Name of Document: VRP Revised Compliance Status Report

Site Name: Georgia Power Plant Kraft

Subject: Response to EPD Comments
Voluntary Remediation Program Compliance Status Report
Savannah Electric - Plant Kraft, HSI Site No. 10415
155 Crossgate Road, Port Wentworth, Chatham County, Georgia

**REVISED VOLUNTARY REMEDIATION PROGRAM
COMPLIANCE STATUS REPORT**

Plant Kraft
Groundwater Analytical Data
Exceeding Comparison Standards
October 2018

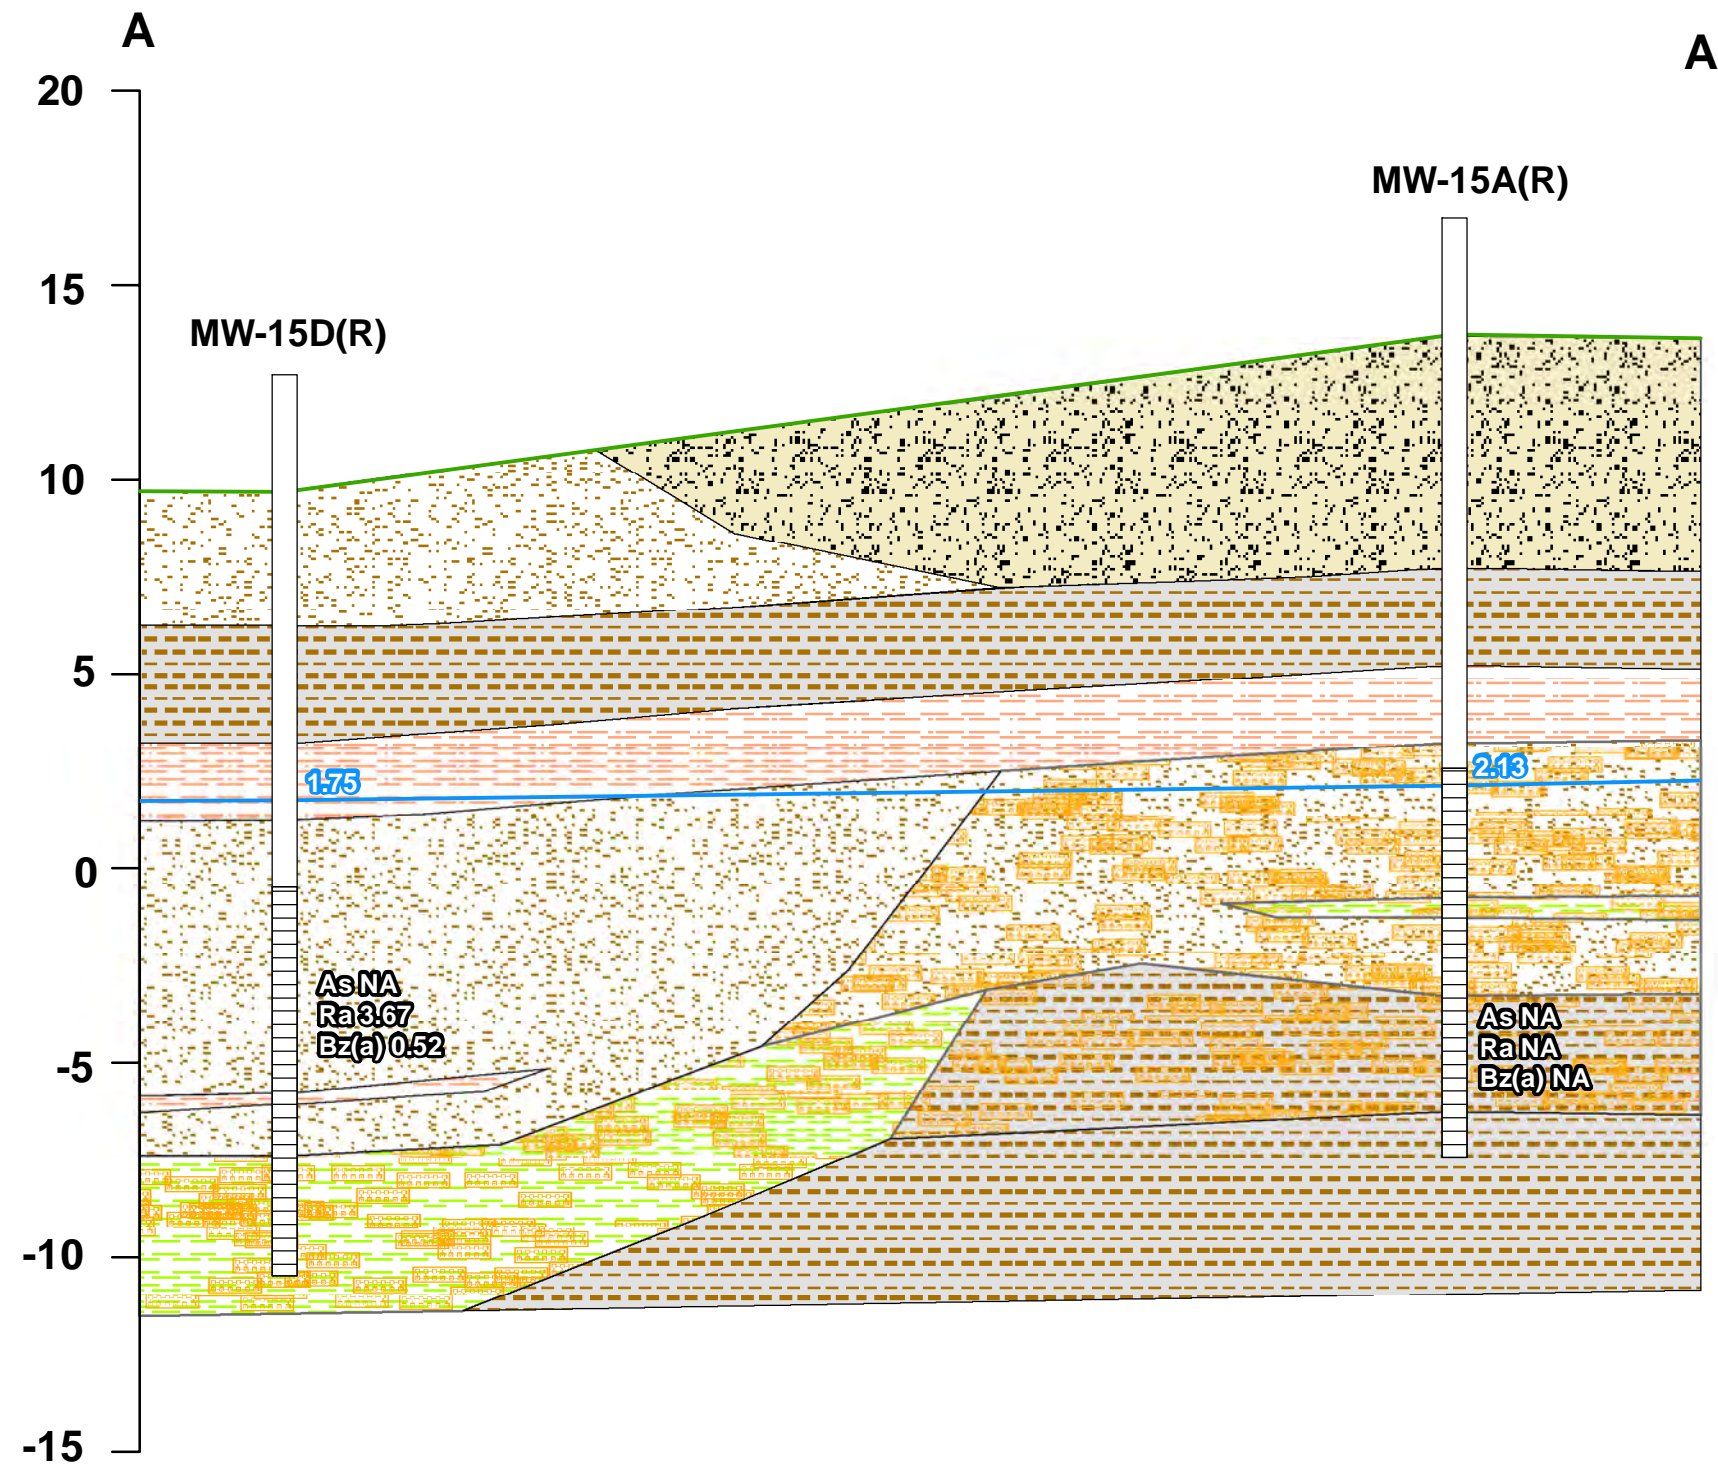
1. An additional groundwater monitoring event should be conducted to further evaluate radium concentrations and geochemical conditions in groundwater in the vicinity of the former ash pond area.

confirmation groundwater characterization is requested downgradient of the inert landfill for VOCs, SVOCs and PCBs. In the event, that existing monitoring wells MW-15D(R), MW-15C(R), and MW-15A (R) are downgradient of the observed waste materials, please provide VOC and PCB analysis for these wells as SVOC analysis has been historically performed.

An additional groundwater monitoring event was performed, and the results are presented in Section 3.4.1.3 on page 24. The results are summarized on Table 5 and shown on Figure 22.

Additional groundwater sampling for VOCs and PCBs was performed, as discussed in Section 3.1.2 on page 20. The results are presented in Section 3.4.2 on page 26. The results are summarized on Table 4A and shown on Figure 22.

Four additional groundwater monitoring wells were installed, and samples analyzed for metals, VOCs, SVOCs, and PCBs. Discussion is presented in Section 3.1.2 on page 20 and Section 3.3.2 on page 21. The results are presented in Section 3.4.4 on page 26. The results are summarized on Table 4A and shown on Figure 22.
